## PERMIT CHANGE TRACKING FORM

Title of Change: Response to review of newly formatted plan, Soldier Creek Coal Company, Banning Siding Loadout, Carbon County, Utah.

Re: Response to Review of Newly Formatted Plan, Soldier Creek Coal Company, Banning Siding Loadout, ACT/007/034, Folder #3, Carbon County, Utah

RE: Draft Review, Second Response to Reformatted Plan Review, Banning Siding Loadout, Soldier Creek Coal Company, ACT/007/034, Working File, Carbon County, Utah

REVISIONS			SC <sup>3</sup> Soldier Creek Coal Company	
NO.	DATE	BY		
1	2-21-09	H. TEW		
2				
3				
SCALE: 1" = 5'			TITLE: DRAINAGE CONTROLS - CROSS SECTIONS	
DRAWN BY: CPA			FIGURE: 7-3	
DATE: 10-12-00

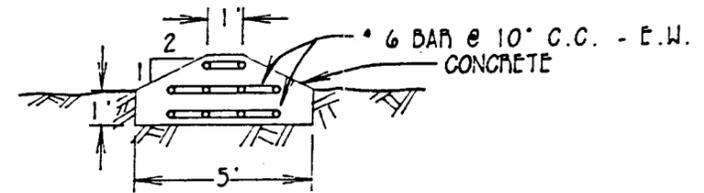
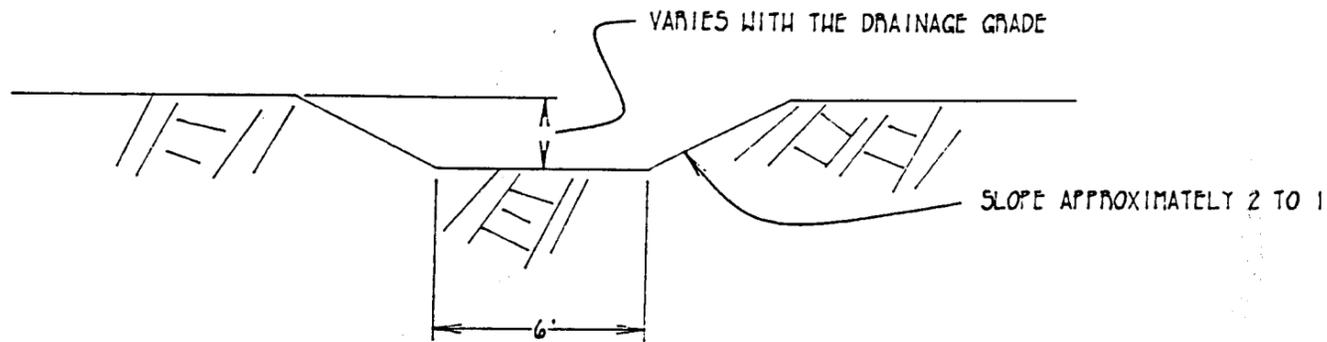
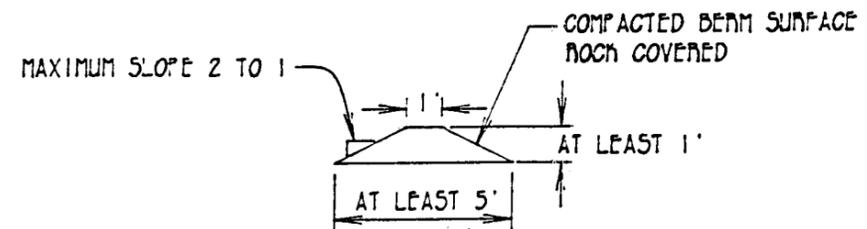
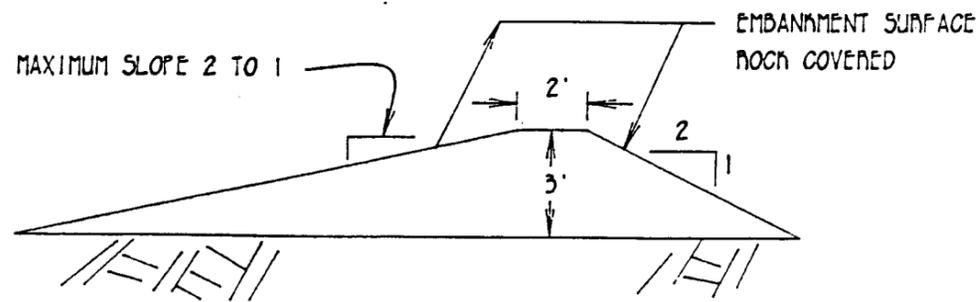
The drive-through shown in Figure 7-3 will be constructed in areas subject to vehicular traffic. These areas include the two exit gates adjacent to the coaling tower and the exit gate along the south fence. An embankment shown in Figure 7-3 will be constructed in the southeast corner of the site. This embankment will direct runoff toward the drainage channel and sedimentation pond.
